Customer : CU-DAR001 Dart Helicopters Services Drawing Name : HELI UTILITY BASKET LH/RH 350/355
 Job Number : 30116
 Estimate Number : 10208
 P.O. Number : N/A Part Number : D350607043
 This Issue : 1/8/2007 S.O. No. : N/A Drawing Number : D350-607 REV F P7-9
 Prsht Rev. : NC Project Number : N/A
 First Issue : N/A Type : LARGE FAB ASSY Drawing Revision : F
 Previous Run : 30002 Material : N/A
 Due Date : 1/18/2007 Qty: 1 Um: Each
 Written By : 
 Checked & Approved By :  07.01.08
 Comment : Est Rev: as Per DSI9318 06-01-24 JLM

DESIGN <i>CP</i>	DRAWN BY <i>CP</i>	DART AEROSPACE LTD HAWKESBURY, ONTARIO, CANADA	
CHECKED <i>[Signature]</i>	APPROVED <i>[Signature]</i>	DRAWING NO. DSI 9318	REV. A SHEET 1 OF 1
DATE 06.01.06		TITLE WASHER ADDITION	SCALE NTS
A	06.01.06	NEW ISSUE

DART SERVICE INSTRUCTION

TO AMEND INSTALLATION INSTRUCTIONS D350-607 REV. F

Figure 5- Basket Replacement Parts
 (D350-607-043 Heli-Utility-Basket™)

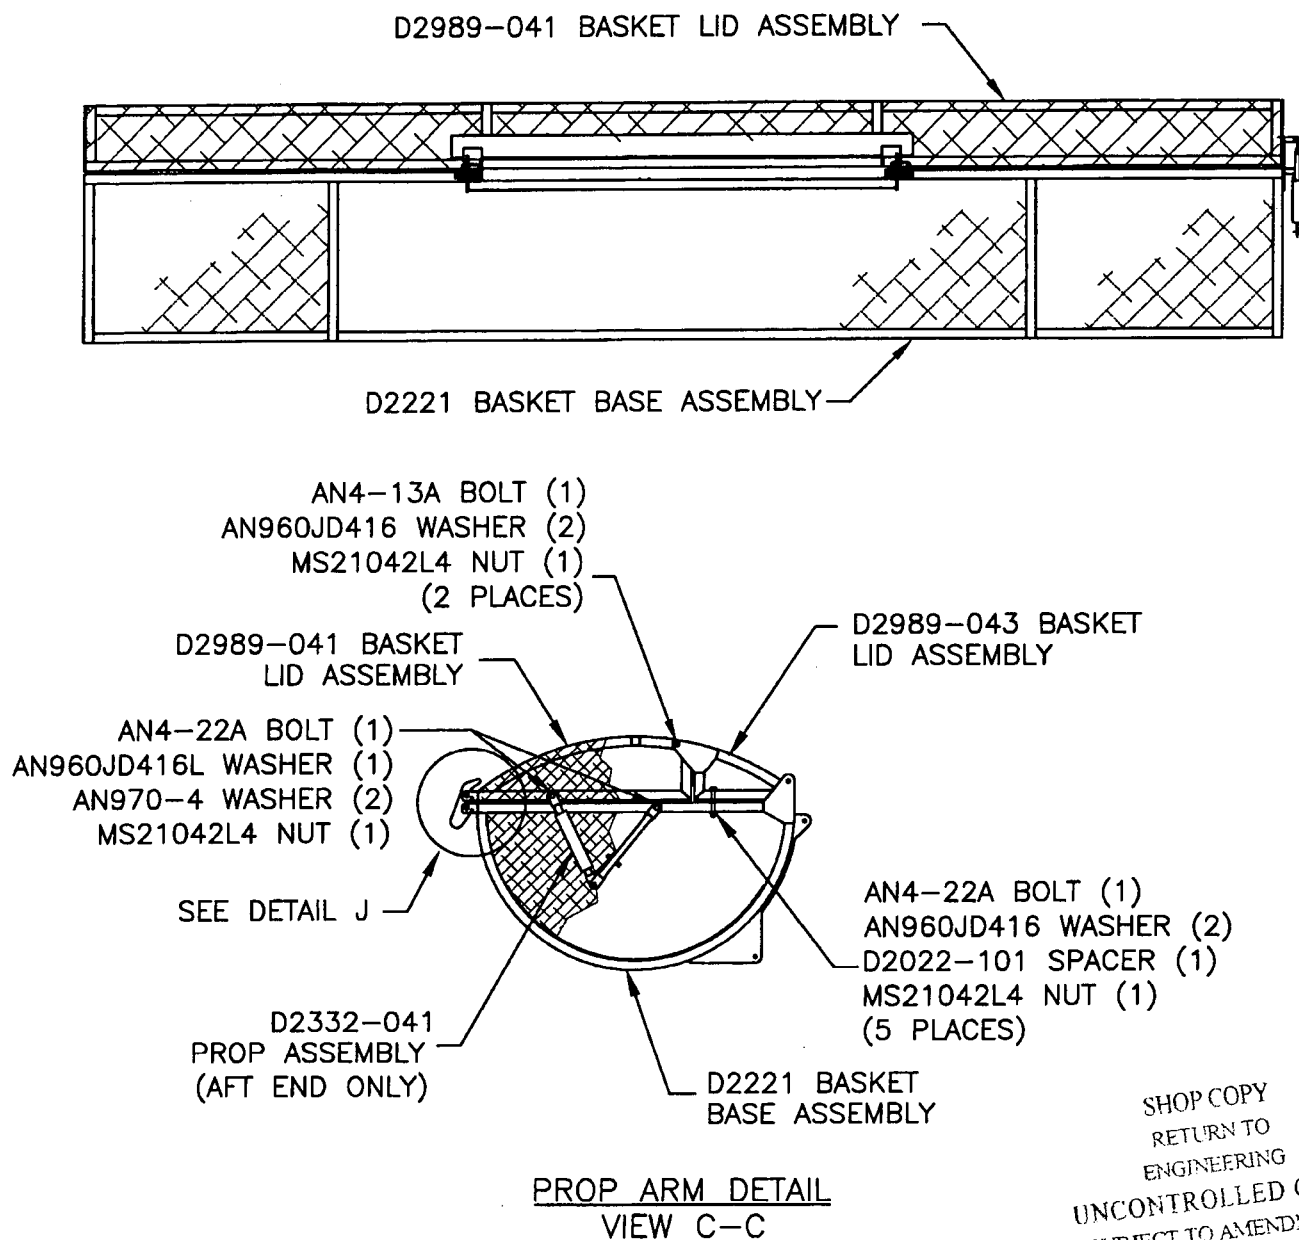
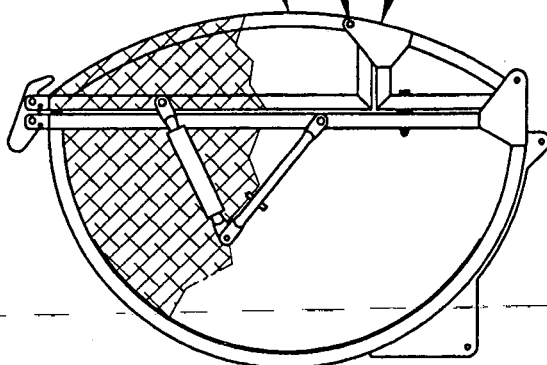
To reduce the possibility of damaging the finish, a **NAS1515H4** washer (2 places) has been added between the hinge plate and basket frame on the **D350-607-043/-047 Heli-Utility-Basket**.

The corrected bolt stackup from Figure 5 of installation instructions D350-607 Rev. F is given below:

AN4-13A BOLT (1)
AN960JD416 WASHER (1)
HINGE PLATE (REF)
NAS1515H4 WASHER (1)
BASKET FRAME (REF)
AN960JD416 WASHER (1)
MS21042L4 NUT (1)
(2 PLACES)
